Comment 819

"CHPE Draft EIS" Comments / [Public Notice NAN-2009-01089-EVA](#)

We write on behalf of Entergy Nuclear Indian Point 2, LLC, Entergy Nuclear Indian Point 3, LLC, and Entergy Nuclear Operations, Inc. (collectively, for the purpose of this filing, "Entergy-IP") to provide comments regarding the sufficiency of (i) the above-referenced permit application submitted by Champlain Hudson Power Express, Inc. and CHPE Properties, Inc. (collectively, "CHPE") to the U.S. Army Corp of Engineers ("USACE") for authorization to construct and operate portions of a 336-mile high-voltage, direct-current ("HVDC") transmission line and affiliated facilities in the waters of the United States (collectively, "Proposed Project"), and (ii) the associated Draft Environmental Impact Statement ("DEIS"), dated September 2013, prepared by the U.S. Department of Energy, Office of Electricity Delivery and Energy Reliability ("DOE"), as lead agency under the National Environmental Protection Act ("NEPA"), 42 U.S.C. §§ 4321, *et seq.* The DOE is considering whether to issue a Presidential Permit authorizing the Proposed Project to interconnect with yet unidentified electric generation sources located

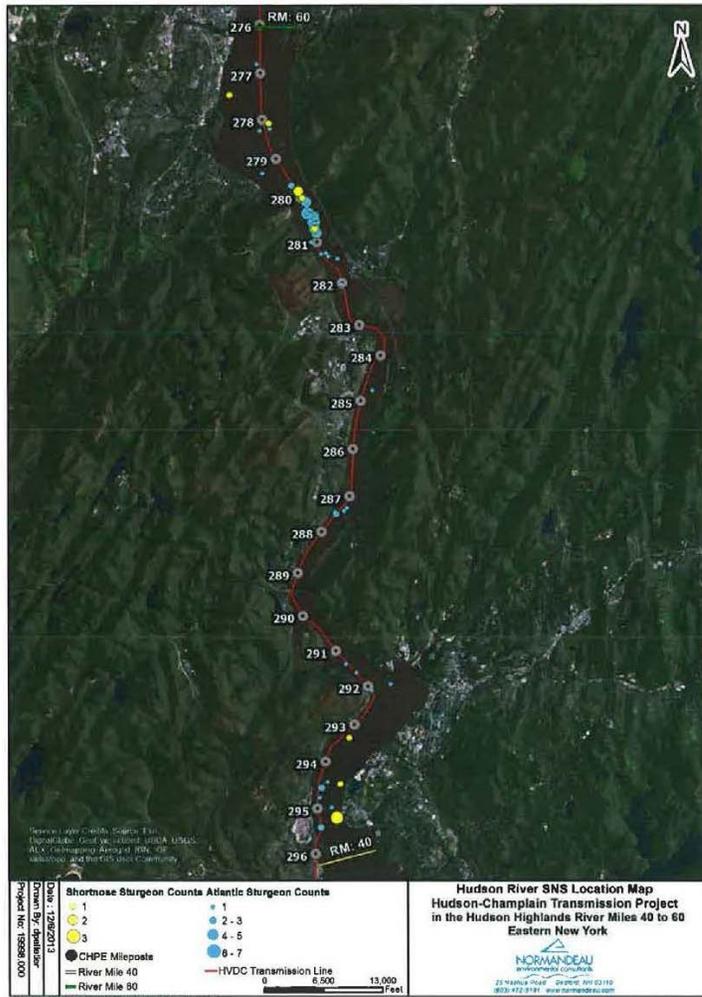
The 2012-2013 HRBMP collected a total of 121 Atlantic Sturgeon and 57 Shortnose Sturgeon during the one-year period from 29 August 2012 through 28 August 2013, and these sturgeon were caught primarily in 3-m beam trawl samples deployed to collect fish living directly (i.e., within 0.7 meters or 2 feet) in association with the river bottom substrate at randomly selected locations throughout the Hudson River Estuary. When the GPS locations of trawl samples catching sturgeon are overlaid on the maps of the CHPE Hudson River Segment transmission line route (Figure 1), it is apparent that more than half (65 fish or 54%) of the total catch of 121 Atlantic Sturgeon came from the upper portion of the Hudson Highlands SCFWH located between Denning's Point and Constitution Island (HRMs 53-59; CHPE MPs 277-283). More importantly, nearly all of these juvenile Atlantic Sturgeon (52 fish out of 65 fish or 80%) came from just one mile of the Hudson Highlands SCFWH (HRM 55; CHPE MPs 280-281) adjacent to Storm King Mountain that is directly in contact with the substrate along the proposed route of the CHPE transmission line (Figure 1). Nearly all of the juvenile Atlantic Sturgeon caught during 2012-2013 from the Hudson Highlands SCFWH near Storm King Mountain were caught during the late summer and fall, indicating that this area is an important and previously undiscovered overwintering habitat for juvenile Atlantic Sturgeon. Thus, any cable embedment activities should avoid this location and sensitive time period to protect the sturgeon. Shortnose Sturgeon also inhabit the same upstream portion of the Hudson Highlands SCFWH as evident by their catch in the 2012-2103 HRBMP (Figure 1). Based on these new observations, in conjunction with the uncertainties about operational EMF and construction impacts on these two federally-listed endangered sturgeon species (Section 2.2 above), and the exact spatial juxtaposition of both overwintering juvenile Atlantic Sturgeon and the CHPE Project transmission corridor, we conclude that at least the upper portion of the Hudson Highlands SCFWH should be avoided by an overland route to protect the sturgeon.

820-57 } **820-57:** As noted in the comment, the potential for impact to this SCFWH would be minor, and the transmission line installation has been approved by the New York State agencies with jurisdiction over SCFWHs. The NYSDOS and the NYSDEC have approved the proposed CHPE Project installation in the SCFWHs through the issuance of the NYSPSC Certificate, the Coastal Consistency Determination, and the issuance of a Section 401 Water Quality Certification.
